PRODUCT CHANGE NOTICE

Packing Method Change for Intersil ZLxxxx QFN Packaged Products

**Refer to:
PCN11007**

Date: January 27, 2011

Tube Outlines – PCN11007

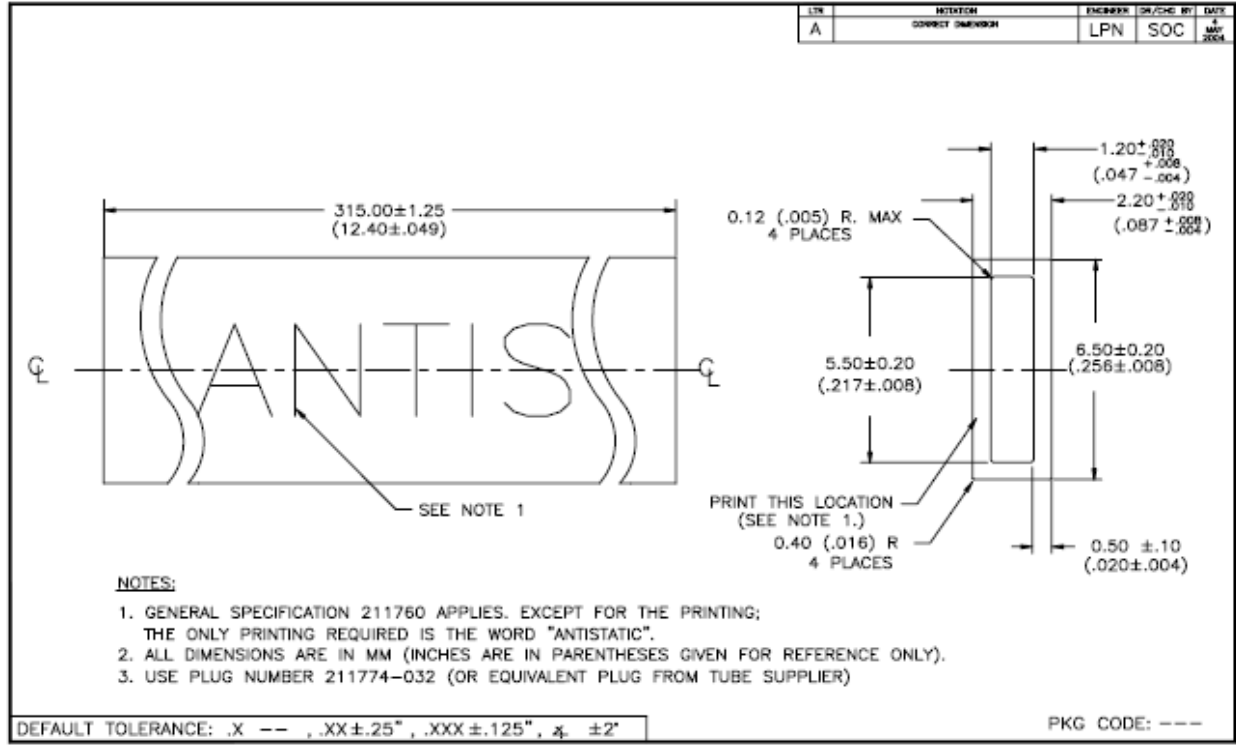
This notice is to inform you that Intersil is changing the packing method for the listed Intersil ZLxxxx QFN (Quad Flat No-lead) packaged products. Intersil will discontinue tray packing and implement packing in anti-static tubes during Q2'2011. The industry standard tubes are made of an anti-static material. Dimensional information and drawings of each type are included for reference. The basic tube information is as follows:

Part Number	Package	Tube Dimensions (millimeter)			Quantity per Tube
		Length	Width	Height	
ZL2004ALNN	32p 5x5 QFN	315	6.5	2.2	60
ZL2004ALNN-01					
ZL2005ALNF	36p 6x6 QFN	315	7.5	2.2	50
ZL2006ALNF					
ZL2105ALNF
